REGIONAL REVIEW FINDING

ARC REVIEW CODE: R911301

Submitting Local Government: City of Alpharetta
Name of Proposal: Sanctuary Park

SUBJECT: **TPD Review of DRI # 2057**
Project: Sanctuary Place
County: Fulton (North)
Location: In Alpharetta, at the intersection of Westside Parkway (Rock Mill Road) and Sanctuary Parkway
Analysis:
Expedited ☐
Non-Expedited ☒

FUTURE 2014 SITE ACCESS TRAFFIC CONTROL AND LANE GEOMETRY
FIGURE 15
A&R Engineering Inc.

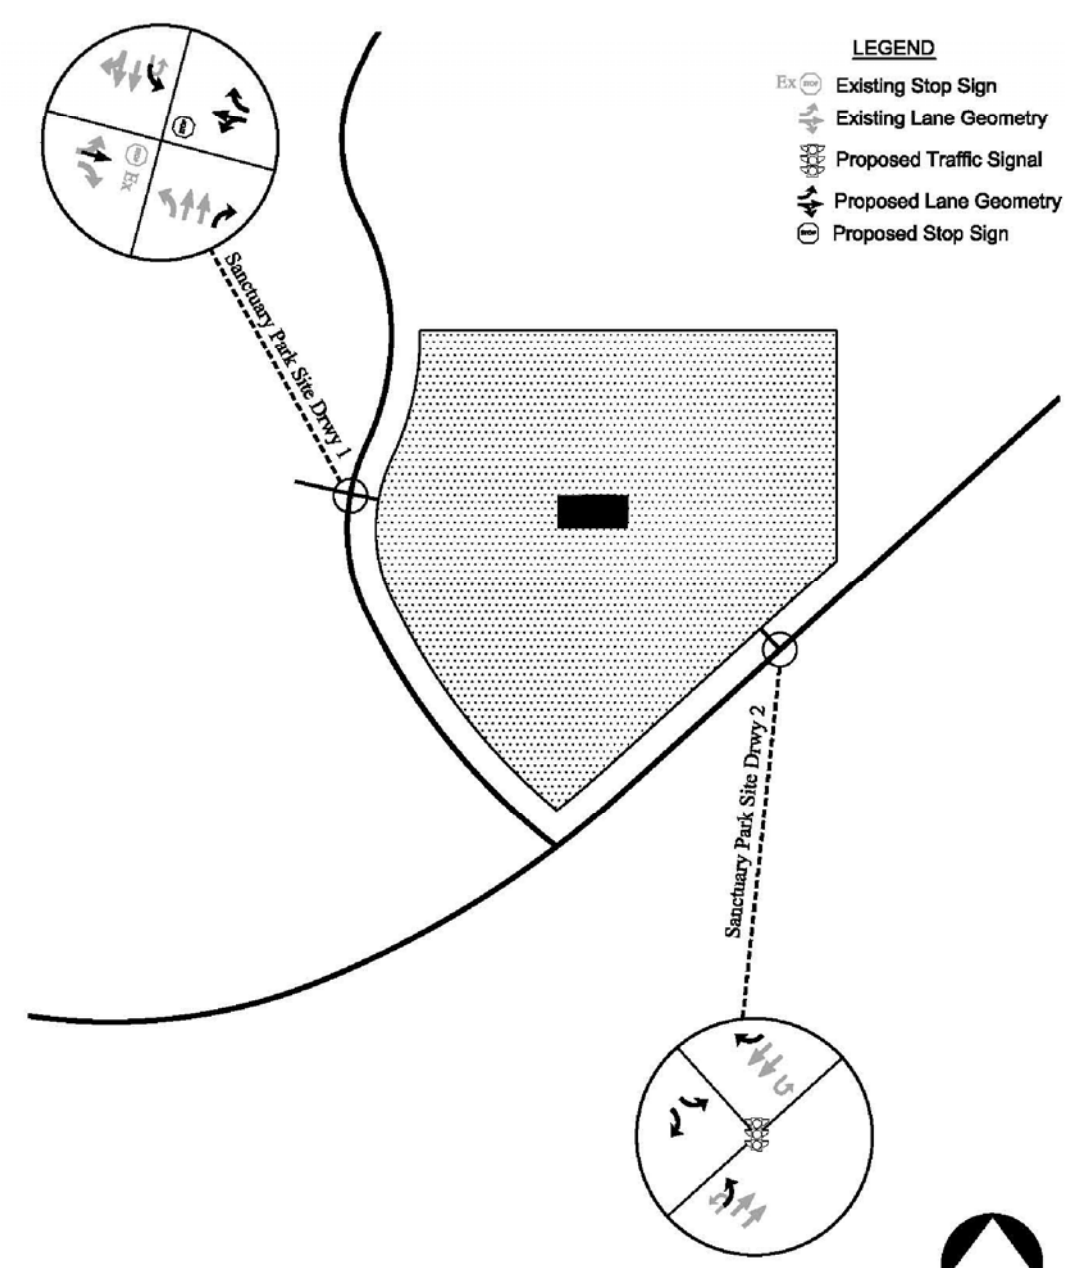
- Intersection of Westside Parkway and Driveway 2
 - The ARC recommends that this driveway be eliminated from the plans, based on preferred Access Management techniques, and based on proximity (600 feet) to the nearest signalized intersection of Westside Parkway and Sanctuary Parkway

- Intersection of Sanctuary Parkway and Driveway 1 (Commercial)
 - Account for additional volume created with the elimination of Driveway 2
 - Consider signalizing the intersection to resolve the currently expected LOS “F”
